SAN FRANCISCO PLANNING DEPARTMENT

CEQA Categorical Exemption Determination

Re: Upper Market Street Safety Project

Re: Upper Market Street Safety Project – Modification to Exempt Project (Case No. 2017-000817ENV)

Figure 1. Summary Map of Proposed Parking and Loading Changes on and adjacent to Market Street Protected Bikeway

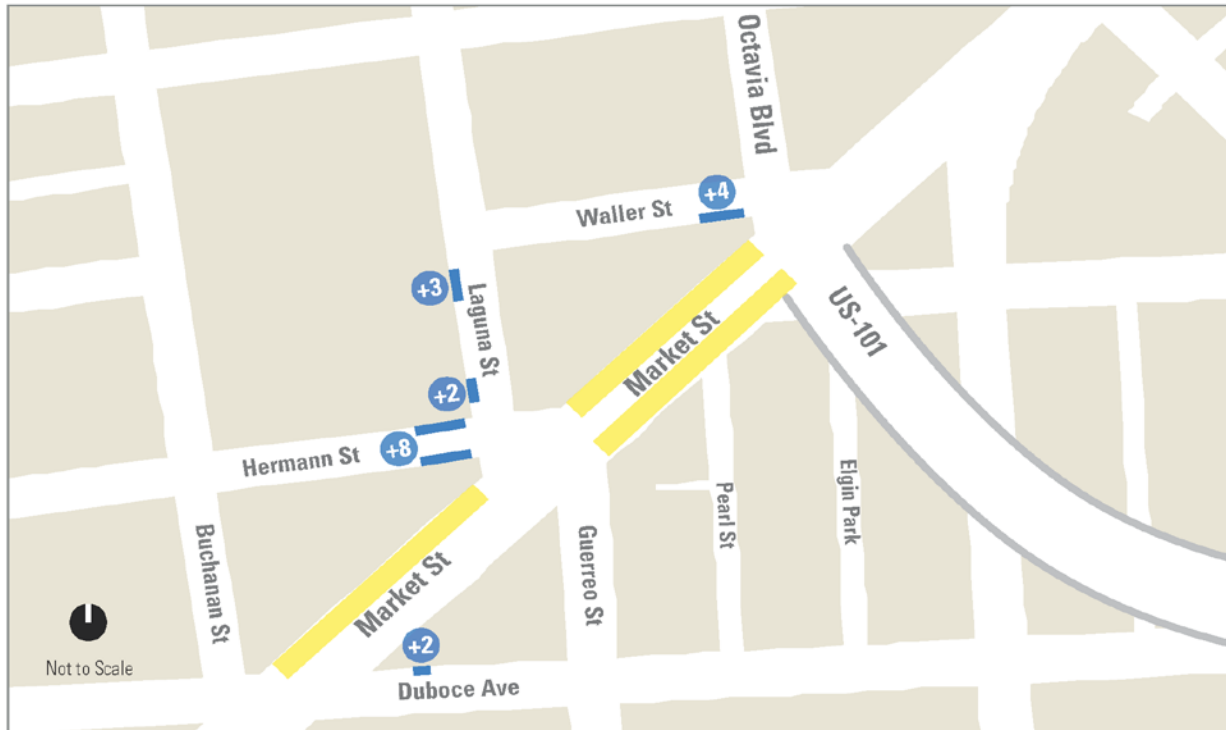
Modifications to proposed parking and loading conditions on Market Street consist of the following:

- Octavia Blvd to Laguna Street, westbound (north side): one 70-foot to 90-foot long, "24/7" passenger load zone at and adjacent to the LGBT Center. Remaining curbspace would be legislated as "Tow Away No Stopping Any Time" (removes approx. 2 additional vehicle spaces).
- McCoppin/US-101 to Guerrero Street, eastbound (south side): one 70-foot to 90-foot long, "24/7" passenger load zone. The two (2) existing commercial load zones would be legislated as "Tow Away No Parking Any Time Except Active Loading" (no net loss of vehicle space, increased loading capacity)
- Laguna Street to Buchanan Street, westbound: one 70-foot to 90-foot long, "24/7" passenger load zone. Remaining curb space would be legislated as "Tow Away No Stopping Any Time" (removes approx. 3 additional vehicle spaces, increases loading capacity).

- Duboce Avenue between Market and Guerrero streets: westbound (north side) up to two (2) metered spaces (replaces existing residential permit Area S, time-limited spaces)
- Hermann Street between Buchanan and Laguna streets: eastbound (south side) up to four (4) metered spaces; westbound (north side) up to four (4) metered spaces (replaces existing unregulated and residential permit Area S spaces)
- Laguna Street, between Waller and Hermann streets: southbound (west side) up to five (5) metered spaces (replaces existing unregulated spaces)

- Waller Street between Laguna and Octavia streets: eastbound (south side) up to four (4) metered spaces and one (1) accessible blue zone (replaces existing residential permit Area S spaces)

The full modified project proposal is anticipated to reduce approximately 33, but as much as 40, vehicle parking spaces in addition to the originally-identified eight (8) motorcycle spaces. Approximately 18, but as much as 40, currently unmetered parking spaces on adjacent and nearby streets will receive parking meters or be modified from current regulations but otherwise retained. (Additional streets that may receive new metered spaces, pending final outreach and design, include Buchanan Street between Market and Hermann streets, and Guerrero Street between Market Street and Duboce Avenue.)

Existing commercial load zones near McCoppin are modified slightly but remain in place, and passenger load zones are extended to each of the blockfaces that includes the Class IV bikeway.

Figure 1 provides a visual map summary of proposed parking and loading changes adjacent/nearby the Market Street Class IV protected bikeway.
